TRINITY METROSM

IFB-23-T026

ADDENDUM #3

THIS ADDENDUM IS ISSUED TO: Revised Plans based on Questions Received

FORT WORTH CITY OF FORT WORTH, TEXAS
TYPE R-1 RESIDENTIAL INTERSECTION REVISED: 04-13-2021
32 13 20-D535

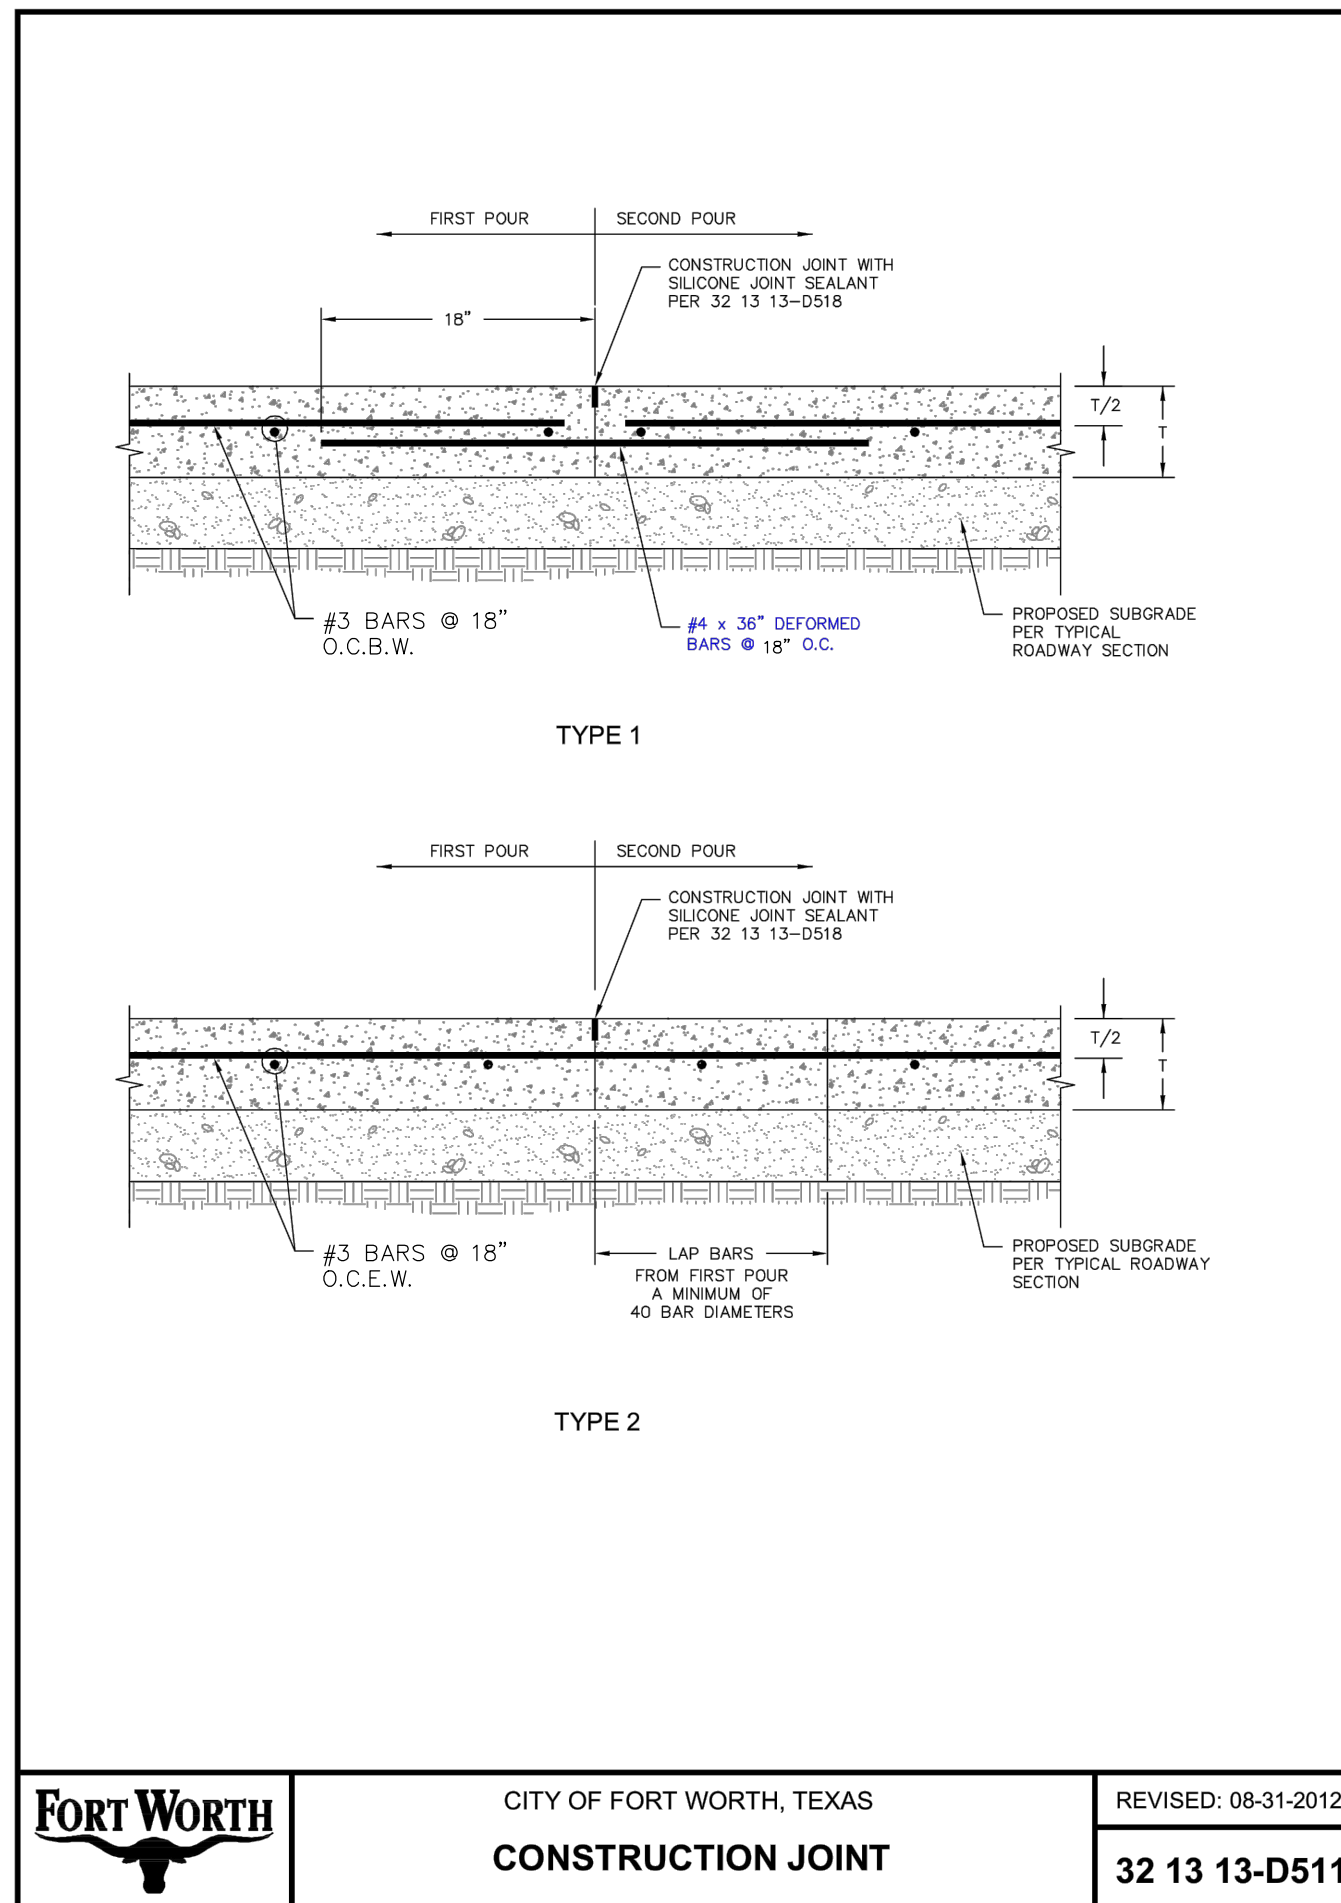
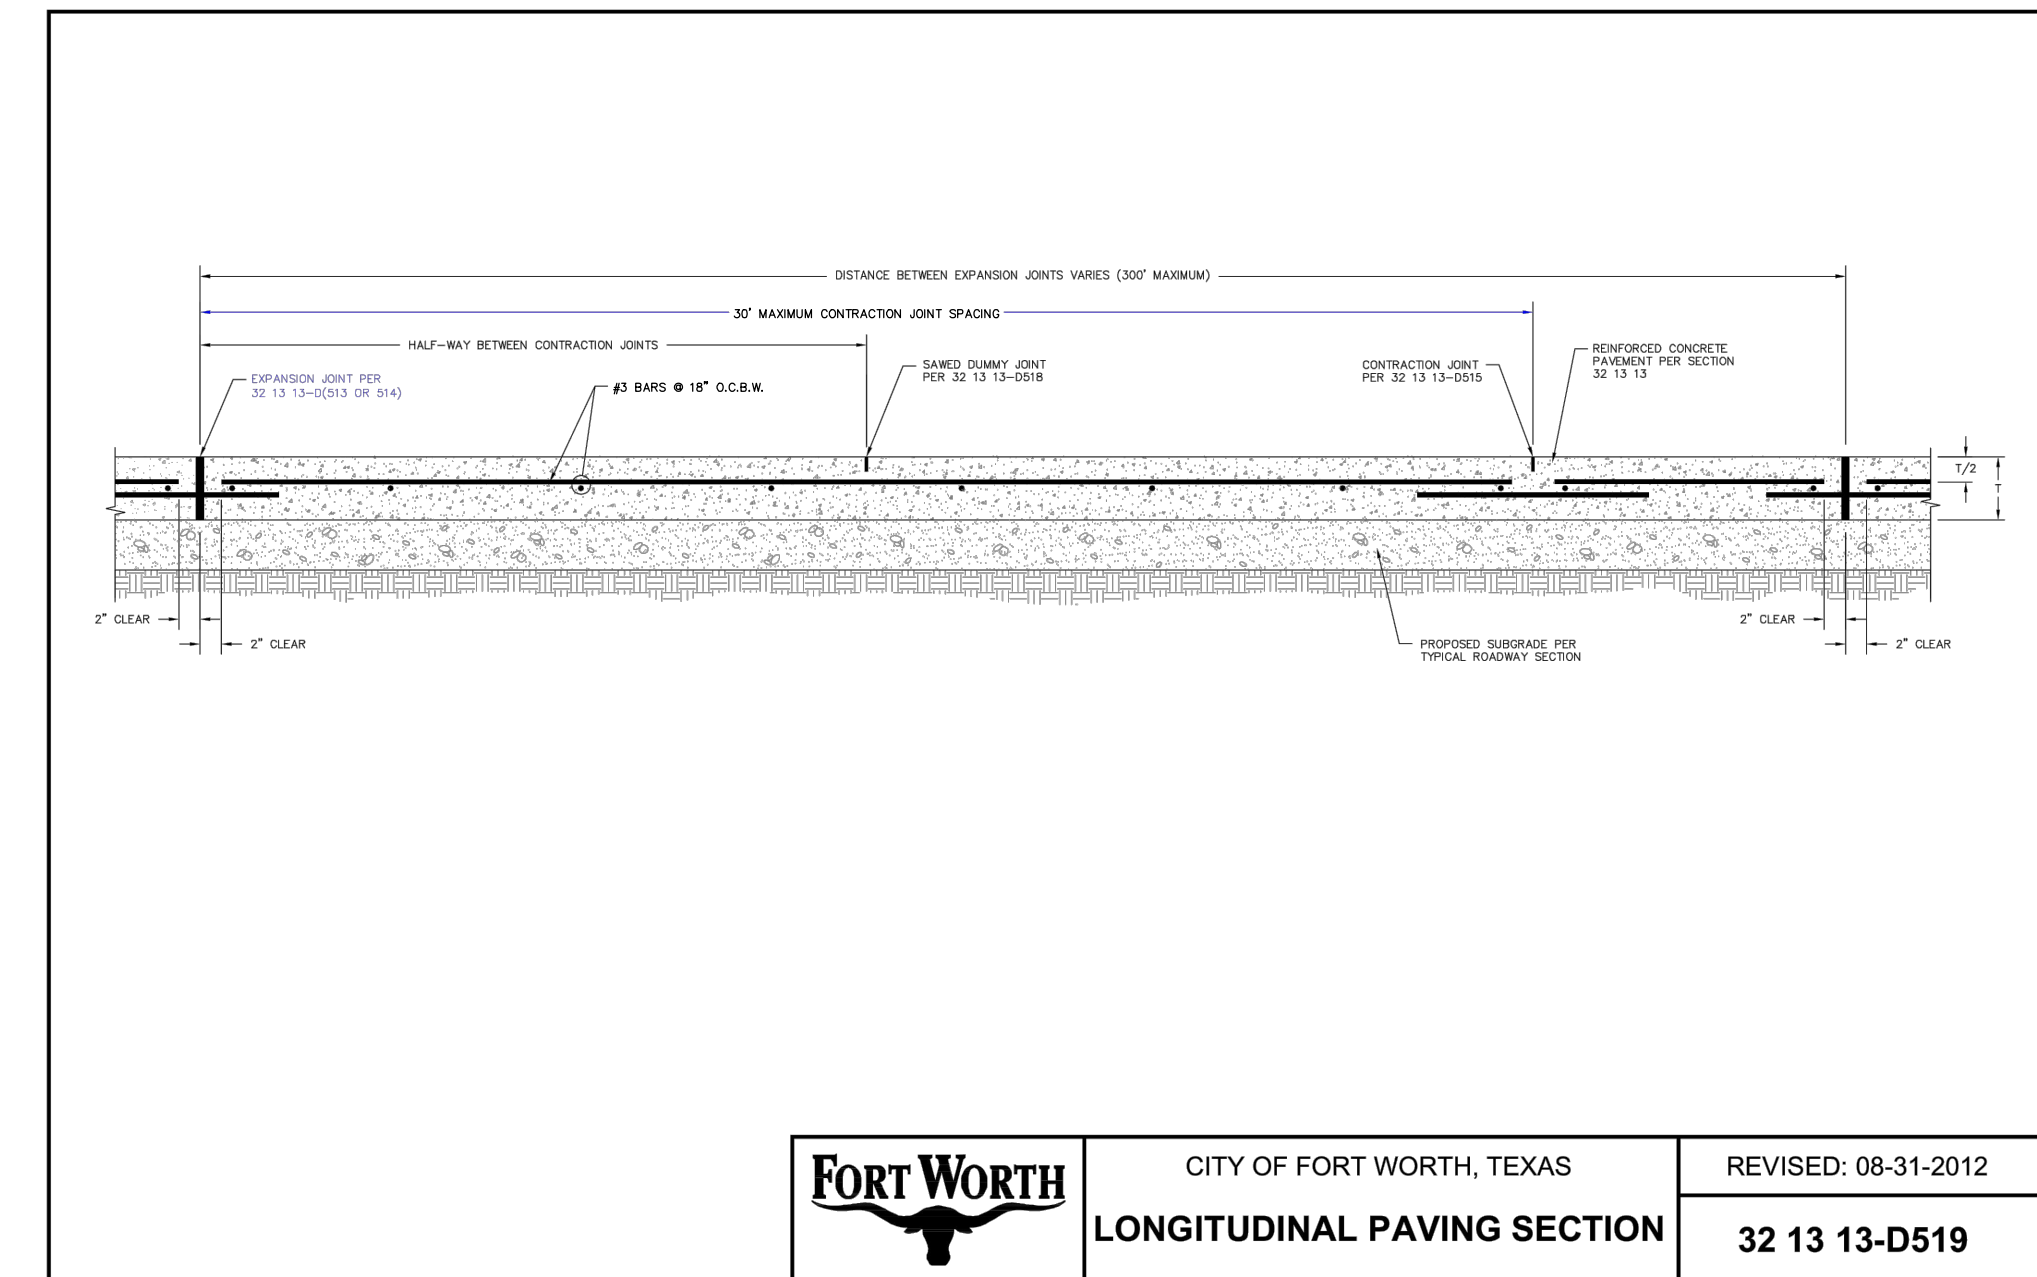
In addition, there are no details for the joints shown in the legend on the paving plans. Please provide details each type of joint.

Revised Drawings C6.1, C6.2 & C6.3, C10.2 & C10.3 are attached.

FORT WORTH
CITY OF FORT WORTH, TEXAS
STREET LUMINAIRE POLE
FOUNDATION DETAILS

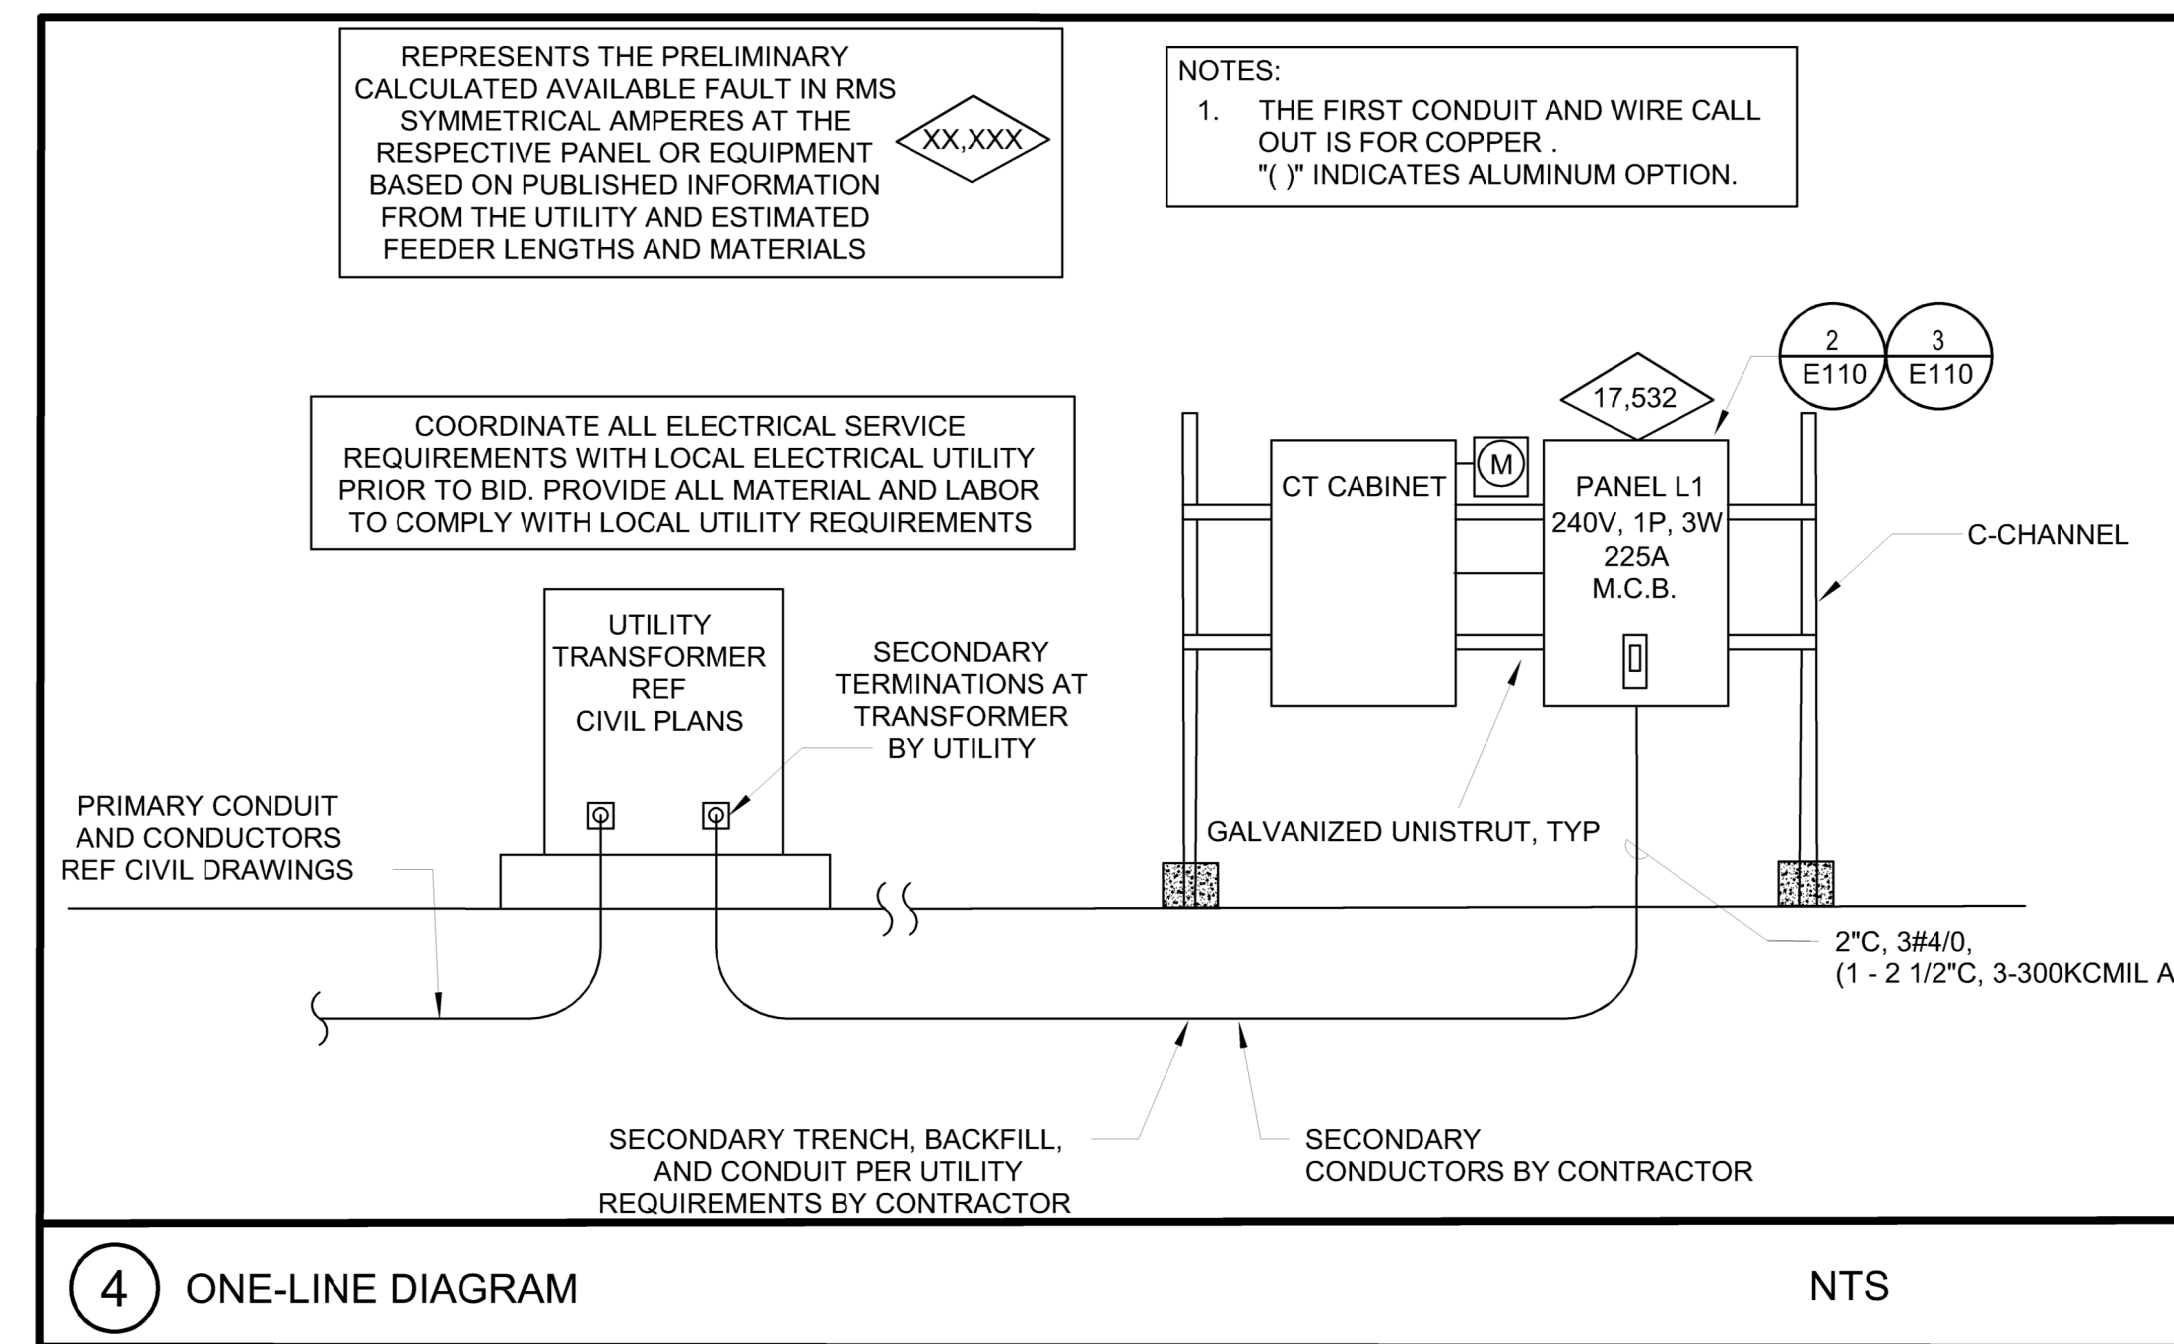
Detail 1 on sheet E110 references MNDOT mix design No. 3Y43 for air entrained 5,000 PSI concrete. Is this correct?

Revised Drawing E110 is attached reflecting the COFW standard for the light pole foundation.
